UNITED STATES PATENT AND TRADEMARK OFFICE

APPLICATION NO.	FILING DATE	FIRST NAMED INVENTOR	ATTORNEY DOCKET NO.	CONFIRMATION NO.
10/622,150	07/16/2003	Matthew Louis Courcy	NSC-P05579	1923

Office Action Summary

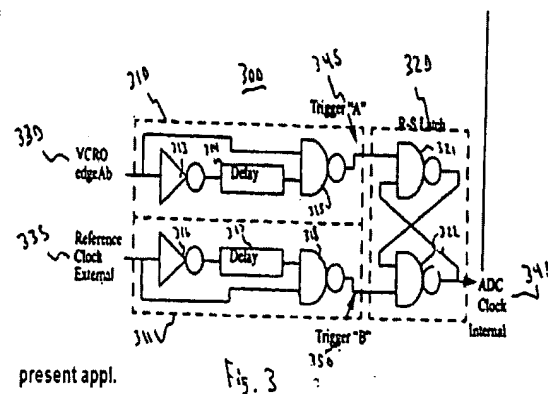
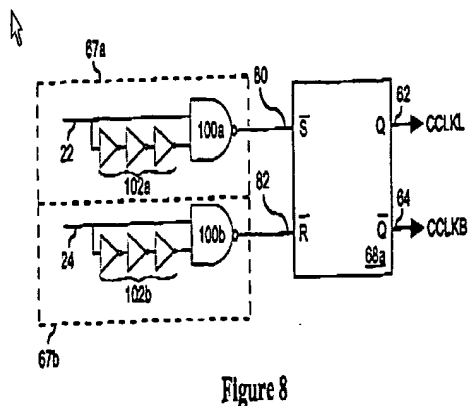
Claims 1-3, and 5 are rejected under 35 U.S.C. 102(b) as anticipated by U.S. P.A.P. 20020017936 A1 to Stark et al. Stark in figure 8 discloses: edge detectors (67a and 67b) and latch/S-R flip flop (66a).

Stark's figure 8 (on the left above) has the same configuration as figure 3 of the present application since the inverters 102a and 102b provide delay circuits. The inputs (22, 24) to the Stark edge detectors are complementary clock signals and 180 degrees out of phase. In the terms of signal period and duty cycle would be one-half clock period delayed phase.
